**TOWN OF OCEAN RIDGE
PLANNING & ZONING REGULAR MEETING
AGENDA**

To:	Planning & Zoning Board Members
From:	Corey O’Gorman, Town Planner
Meeting Date:	September 15, 2026
Subject:	30 Oceanview – Development Plan Review

PLAN REVIEW REPORT
30 Oceanview Drive
02/16/2026/~~Revision 03/25/26~~
~~Revision 05/12/26~~
~~Revision 6/25/26~~

Subject: Site Plan Review Comments
30 Oceanview Drove (DPR)
CAS Project No. 08-26-008

FRONT ELEVATION ARTICULATION DIAGRAM
SCALE : 1/4" = 1'-0"

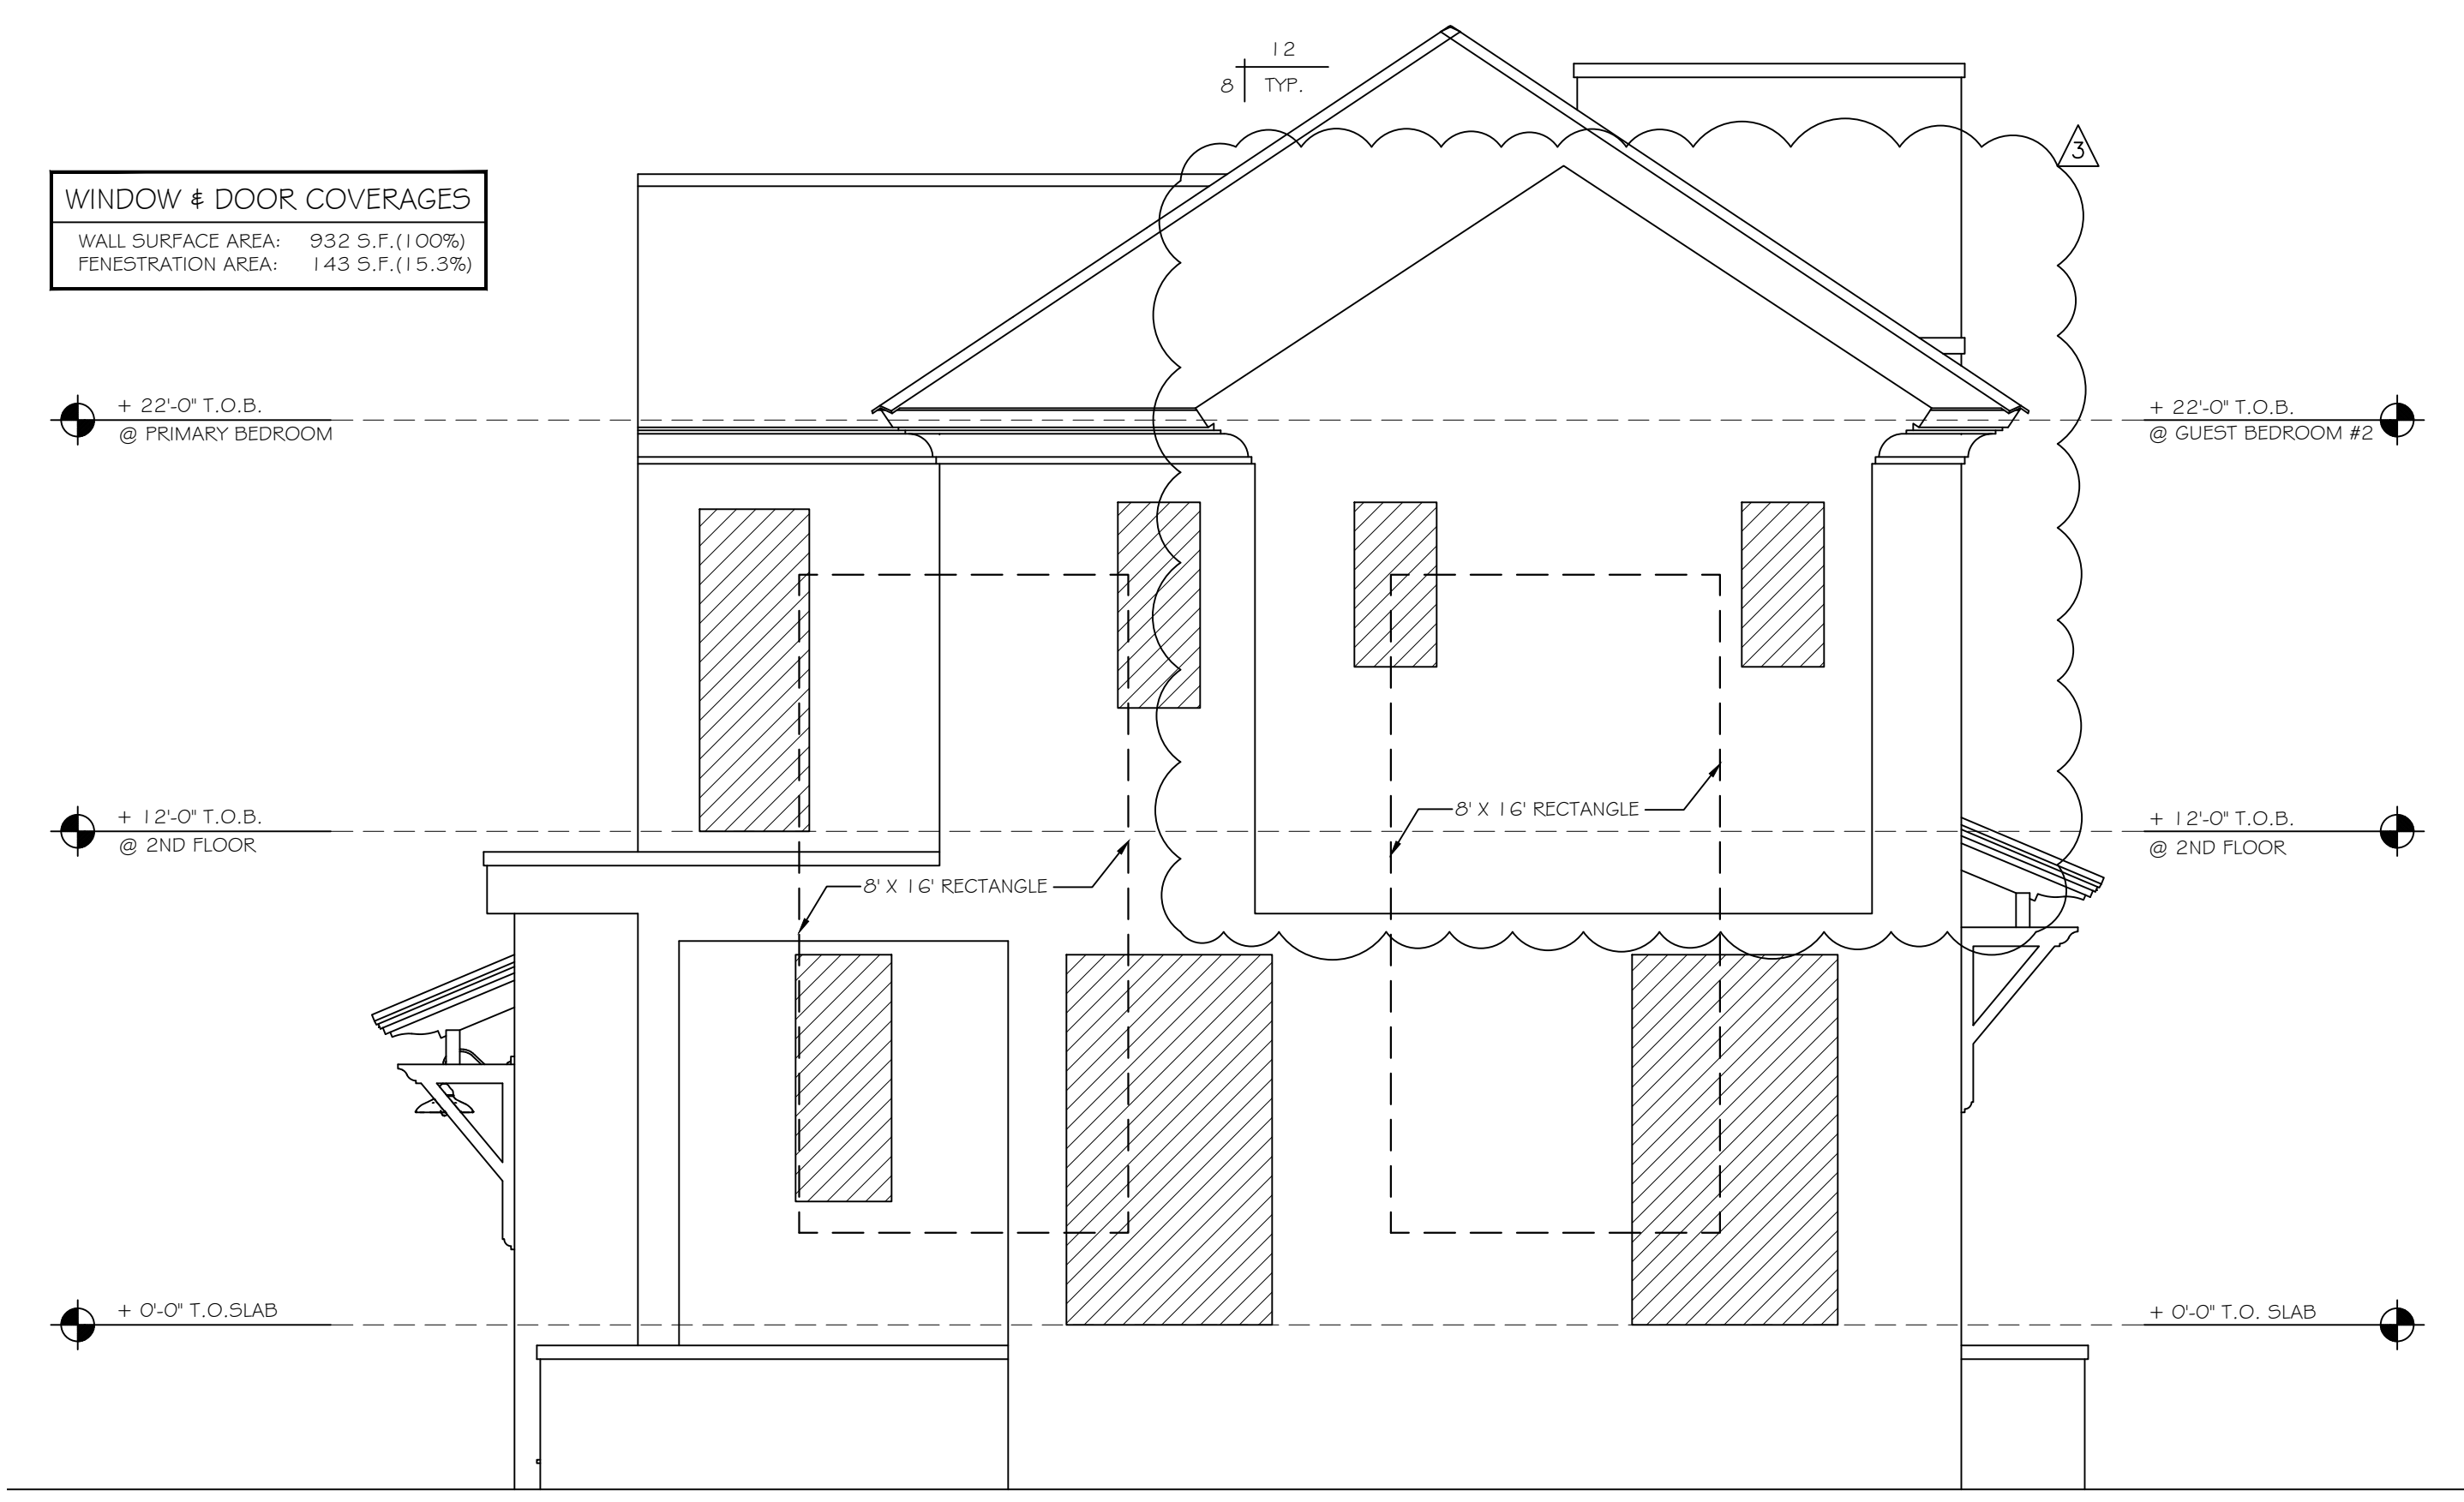
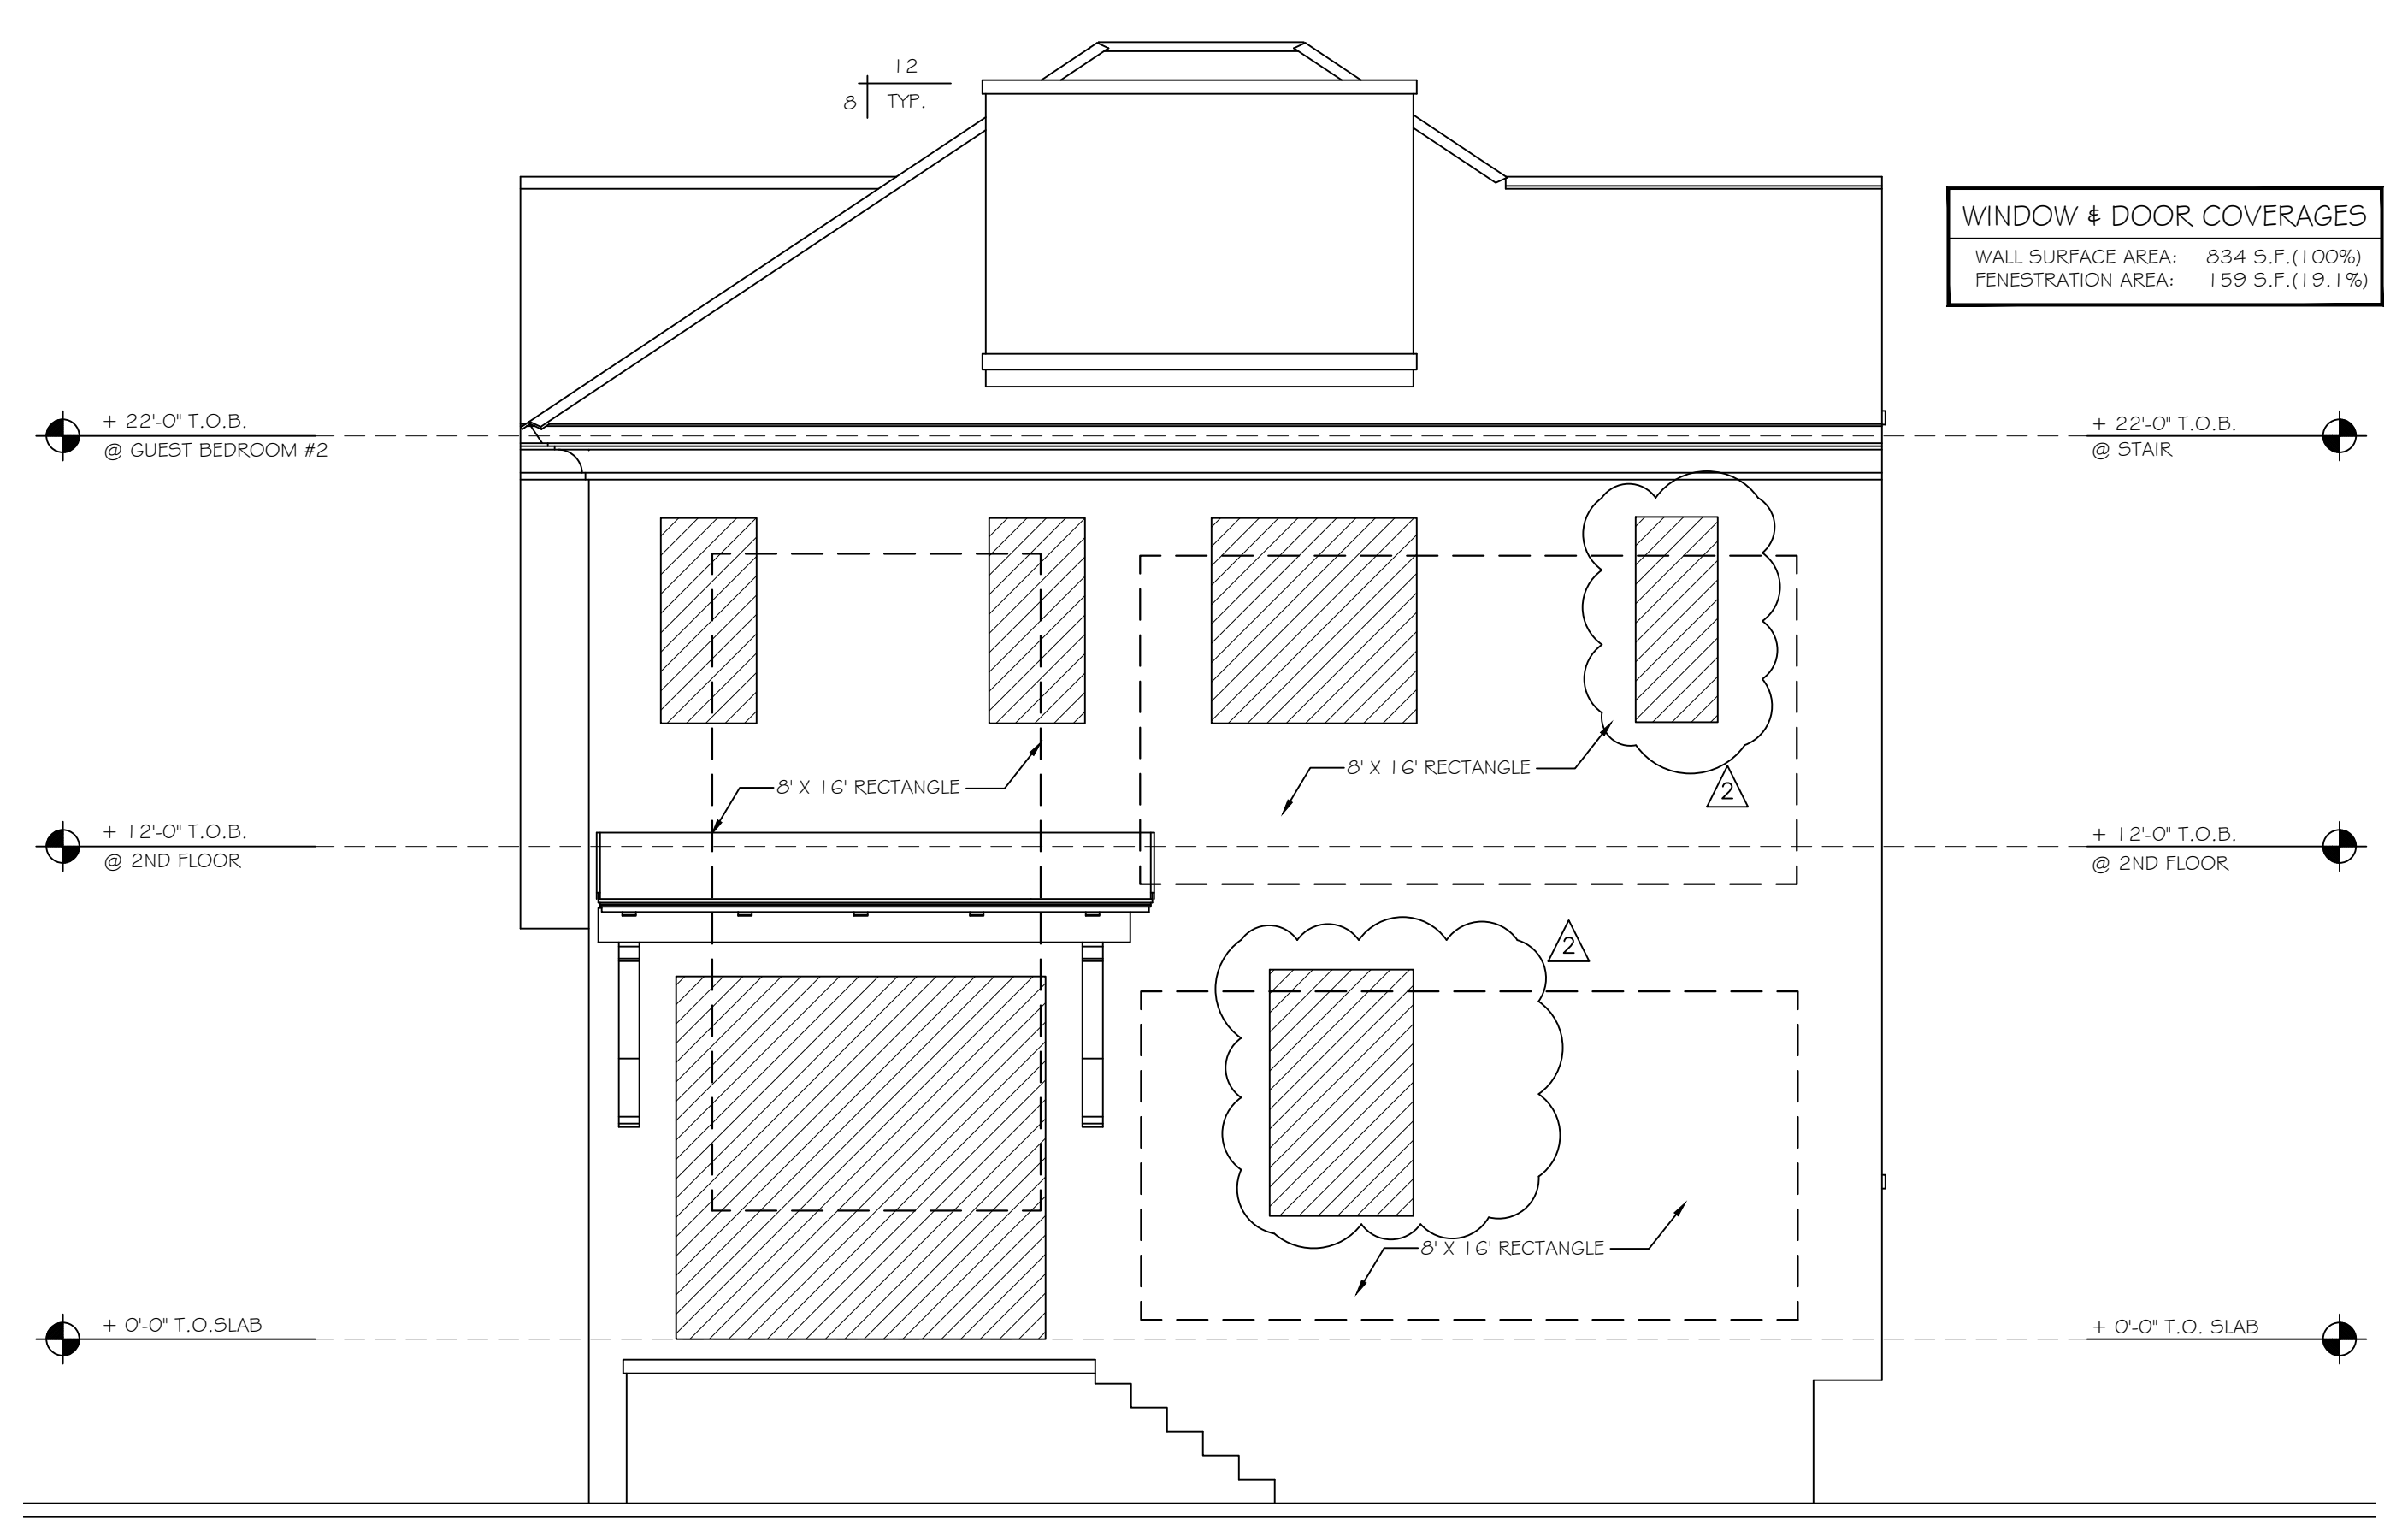
Section 64-3(d) **Background:** This code section addresses the minimum setbacks including side setback for principal structures in the Ocean View Special Area. There are several exceptions to the minimum required setbacks including 64-1(h) for dormers and gabled ends, 64-1(j)(2) for exterior balconies, bay windows, exterior chimneys, or other architectural features which do not measure more than 25 SF in the horizontal plane, and eaves which do not extend more than 3' from the vertical wall, and

64-52 for height and yard exceptions allowing a roof overhang to project into the setback. The plans show an encroachment into the side setbacks on both the east and west elevations.

The Town Code allows architectural features to encroach into the setback provided that they do not measure more than 25 SF in the horizontal plane, and eaves which do not extend more than 3' from the vertical wall, however the code does not include a definition for "architectural feature". Consequently, this report recommends approval subject to compliance with the 25 SF and 3' extension, and determination by the Planning & Zoning Board if this qualifies as an architectural feature.

The architect's response: "The encroachments have been removed. To provide an architectural feature, the plans were revised. The architectural feature will be constructed under the roof overhang as a standard over frame having a stucco finish at the second floor only, providing our decorative gable end feature." In addition, the "architectural feature" is described as a "standard over frame having stucco finish at the second floor only" and is constructed "under the roof overhang".
